## **ADDENDUM G (NON-DSA APPROVAL)**

**PROJECT:** Santa Ana College  
Science Center

**DATE:** 9/01/2017

### **RESPONSES TO PRE-BID CLARIFICATION (“PBC”)**

DATE:	August 7th, 2017		
FROM:	Luis Giordano McCarthy Building Companies	EMAIL:	lgiordano@mccarthy.com
SPECIFICATION NUMBER:	033000	DRAWING NUMBER:	S3.02

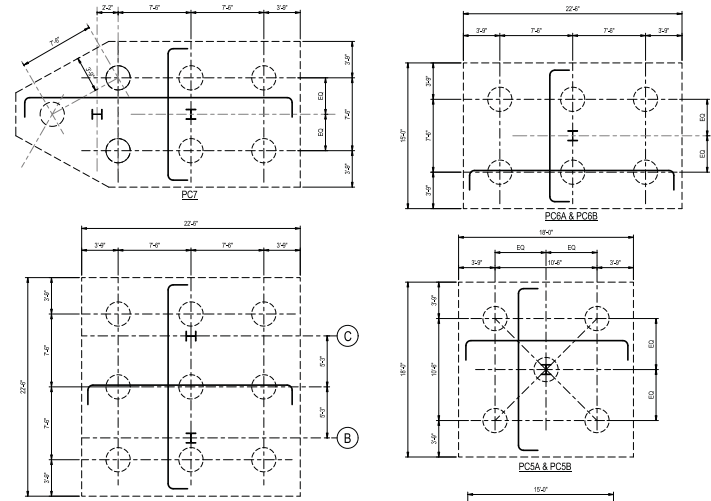
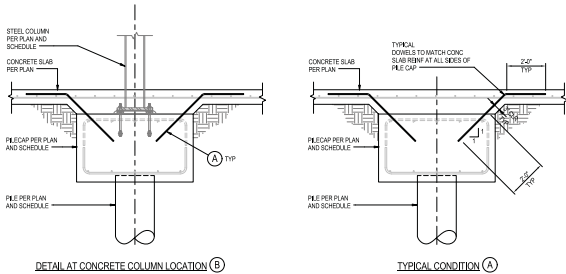
Detail 1/S3.02 there is a pile cap labeled PC6, however on the plans there is no PC6. Please confirm this pile cap should be PC6B in the schedule.

Please see attached mark ups to clarify the pile cap designations. Will be updated in the Addendum #2 drawings.
